September 28, 2020

Re: Appeal of the Initial Decision Regarding the Request for Correction to NIST's Final Report on the Collapse of World Trade Center Building 7 (Information Quality #20-01)

Part 1: NIST’s Computer Simulations

Figure 12-62. Exterior column buckling after initiation of global collapse with debris impact and fire-induced damage (slabs removed from view).

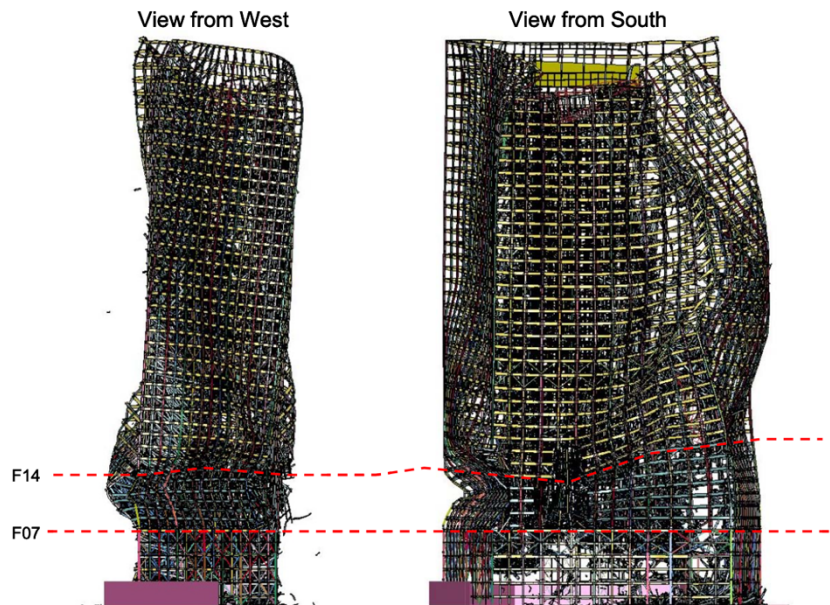
1. First and most apparent, NIST's global collapse analysis predicts significant deformation of the upper exterior walls both before and after the initiation of global collapse. Yet, per NIST's own observations, there is no observed deformation or displacement of the upper exterior corners as late as 7.5 seconds after the initiation of the east penthouse collapse (which is .6 seconds *after* NIST claims that global collapse initiated). Figures 5-199, 5-200, and 5-201 from NCSTAR 1-9, which compare the position of WTC 7's exterior at 5.0 seconds and 7.5 seconds after the initiation of the east penthouse collapse, demonstrate the

total absence of deformation or displacement in the upper exterior corners, with NIST actually commenting: “Interestingly, little movement of the northeast and northwest corners of the building is indicated.” (See NCSTAR 1-9, p. 274.) Meanwhile, the NIST global collapse analysis predicts significant deformation of the upper exterior walls both before and after the initiation of global collapse. The four figures shown on pages 30 and 31 of the Request (including Figure 2 shown above) illustrate the increasing deformation of the upper exterior walls predicted in NIST’s global collapse analysis at four different points in time by overlaying each animation frame on top of the animation frame just before the initiation of the east penthouse collapse (which is at 16 seconds in NIST’s global collapse analysis animation). The next three figures, shown on page 32 of the Request, juxtapose video of the collapse with NIST’s global collapse analysis at 5 seconds, 7.5 seconds, and 8.1 seconds after the initiation of the east penthouse collapse. In addition, Figure 12-62 from NCSTAR 1-9, shown on page 33 of the Request and below, illustrates the significant deformation of the exterior predicted in NIST’s global collapse analysis, with the upper eastern exterior folding inward to the south dramatically, as acknowledged by NIST: “In both analyses, the eastern exterior wall deflected inward at the roof level as the structure became unsupported after the vertical collapse event.” (See NCSTAR 1A, p. 44.) However, this behavior was not observed in any videos of the collapse.

1. Revise the NIST WTC 7 Report to reflect that the north face roofline underwent a sudden transition to free fall, as shown in detail from page 35 to 39 of the Request. Then perform a new global collapse analysis that both is physically possible (i.e., does not involve the walk-off of Girder A2001 at its Column 79 support nor a cascade of floor failure from Floor 13 to Floor 5) and matches the observed behavior well (e.g., the scenario simulated in the UAF analysis). Then discard the Probable Collapse Sequence and adopt a new probable collapse sequence that both is physically possible and better matches the observed behavior; or

Figure 8: NCSTAR 1-9 Figure 12-62 View from West (left); NIST’s global collapse analysis at 8.1 seconds after east penthouse collapse initiation laid over .1 seconds before the east penthouse collapse initiation (right).

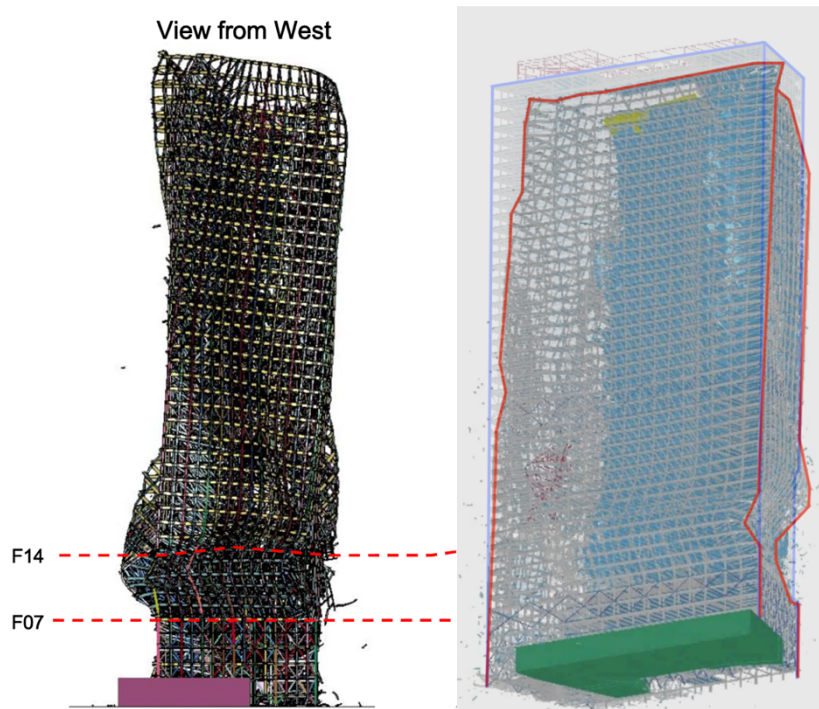
In contrast, NIST’s global collapse analysis predicts both the northeast and northwest edges of WTC 7 tipping to the south — not to the north — in a manner that appears they would not have tilted back to the north and, in the case of the northwest edge, that it would not have settled back to its original line. The southward tipping predicted in NIST’s global collapse analysis is shown on page 35 of the Request and below in the western view from Figure 12-62 of NCSTAR 1-9 (left) and in the overlay of the final frame from NIST’s global collapse analysis animation on top of the frame just before the initiation of the east penthouse collapse (right).

It should be noted that the illustration and animation of NIST’s global collapse analysis shown in Figure 8 below correspond approximately to the position of WTC 7 at 8.3 seconds in the video, at which point there is no tipping or tilting of the building (see “8.3 s”). It is apparent that at the rate of tipping shown in the global collapse analysis, approximately 3 seconds later the model would have shown the building tipping southward dramatically far from its original position.
